INDESIT company

PWDE7145WEU

F062591

Technical Documentation guidelines

n4012a00: USE 5-WAYS HARNESS FOR CONNECTION MAIN MODULE /UNIT INTERFACE

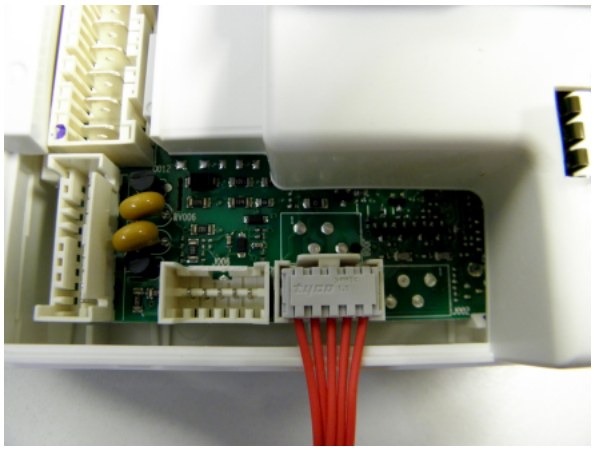
When replacing main module on machines with serial number AFTER srial 10626.0001 it must be used the 5-way harness (between main module and unit interface) spare part code C00266848, removing the 4-way harness present in the machine (see attached picture of the connection).
The use of the 5-way harness is mandatory for a correct compatibility between main module (actually managed as spare part) and unit interface on the product.
If the intervention is not done using the 5-way harness the washing machine, after first stand-by, will never turn on again.
